SUMMARY

PROPERTY:	2-6 Pilgrim Avenue (Lot 0 SP 8785, Lot 9 DP 15917, Lot 8 DP 15917) & 11-13 Albert Road (Lot B DP 100558 and Lot A DP 100558), Strathfield
DA NO.:	2020/256
APPLICATION TYPE:	Site preparation works including demolition, tree removal, remediation works, and excavation, and construction of a part 11, part 15 storey mixed-use development comprising 168 dwellings, two (2) ground floor commercial spaces and four (4) basement levels, as well as ancillary and landscaping works.
COST OF WORKS:	\$50,797,457.00
REPORT BY:	J Gillies
RECOMMENDATION:	APPROVAL (DEFERRED COMMENCEMENT)
NOTIFICATION:	13 January – 12 February 2021 and 8 July – 22 July 2021
SUBMISSIONS:	Forty eight (48) written submissions received during the first notification period, all objections. Forty five (45) of the submissions were proforma. Following design changes, the Application was re-notified to members of the public who had made submissions during the original notification period. An additional four (4) written submissions were received.

EXECUTIVE SUMMARY

Figure 3 – Comparison of the original and revised proposal (western elevation)

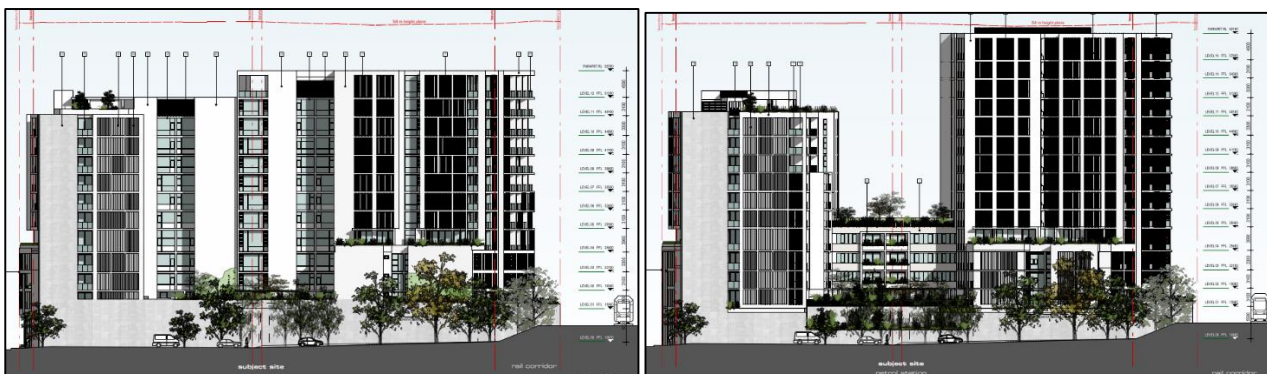
The elevation facing the railway is how most people will view the proposed building. This elevation has a simple and blank expression and would benefit from additional detail and articulation. The Panel recommends that this elevation requires further articulation and development.

The units, where the Pilgrim notation meets the Albert notation on levels 2, 3 + 4, have greater potential as dual fronted units – the current design is not planned well and a full redesign of these units should be undertaken to maximise the potential amenity of these apartments.

The final design submitted by the Applicant generally address the above, or provides sound justification for why an alternative was explored. In summary, the following revisions to the design address the above as follows:

Figure 8 – Balconies adjoining the rail line (floorplan view)

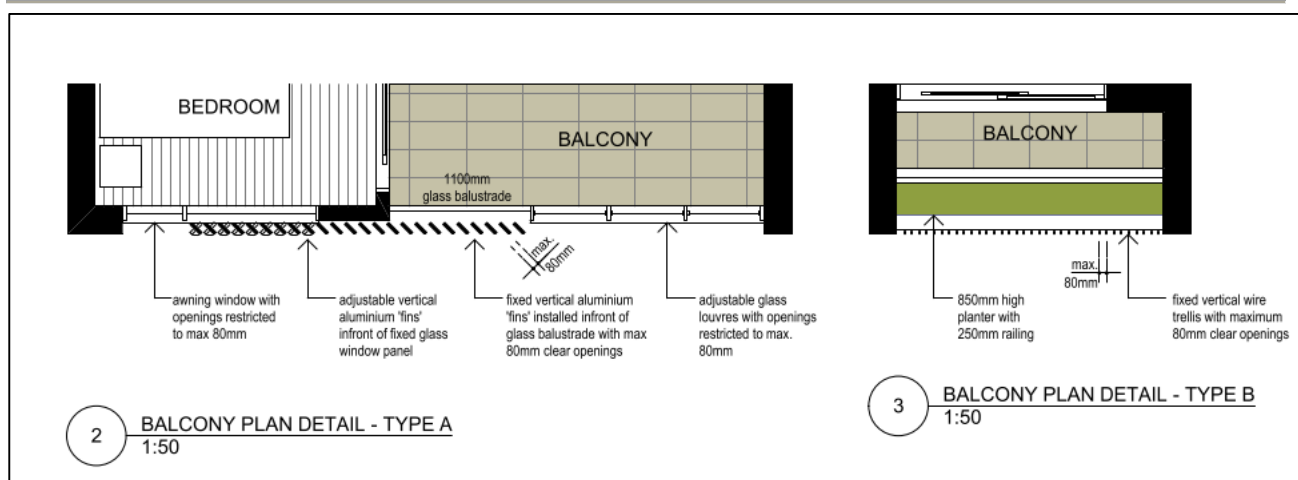
9.2 *The architect explained that wintergardens are provided to the apartments on Levels 2 and 3 facing the railway to mitigate noise and pollution impacts and assist with safety. The Panel notes that as wintergardens are enclosed they are likely to count as FSR, and further questions if wintergardens will allow these units to achieve ADG compliant natural cross ventilation. The Panel questions the absence of similar strategies to mitigate noise and pollution for apartments on other levels facing the railway, on Level 1 and on Level 4 and upwards.*

During the Assessment, Council had identified and discussed with the Applicant that the balconies within Building P that face the rail corridor and incorporate a combination of fixed privacy fins, operable louvres and glass balconies had the appearance of being enclosed and may be counted towards GFA. Accordingly, Council recommended the Applicant submit a Clause 4.6 Variation Request justifying the exceedance in floor area.

The Applicant has submitted 'precautionary' Clause 4.6 variation request, maintaining their position that the balconies do not incorporate an enclosed structure and therefore should not be counted towards GFA.

- In response to the site-specific consequences, a combination of fixed open fins and adjustable glass louvres above a balustrade are proposed for the 41 balconies on Level 2 and above which face the railway corridor, to prevent opportunities for objects to be thrown onto the railway corridor. The fixed fins have a maximum opening width of 80mm to comply with Sydney Trains' requirements.
- An analysis of the proposed balcony facades shows that on average, 37% of each balcony façade is balustrade, 25% is composed of fixed open fins, and the remaining 38% is composed of adjustable glass louvres. As over a quarter of the balcony façade is permanently open, it is considered that the balconies represent open space, and are not enclosed for the purposes

Figure 9 – Balconies adjoining the rail line (elevation view)

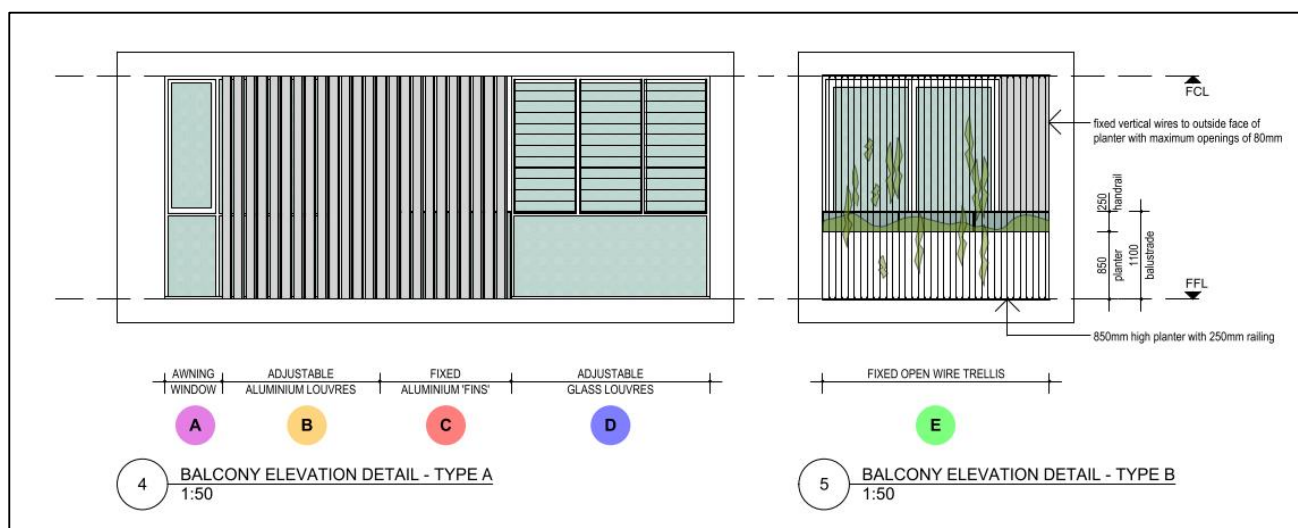
The Panel questioned how adequate acoustic attenuation to the apartments facing the railway corridor is ensured whilst providing natural ventilation and advised that glazing or screening may be required to the balconies.
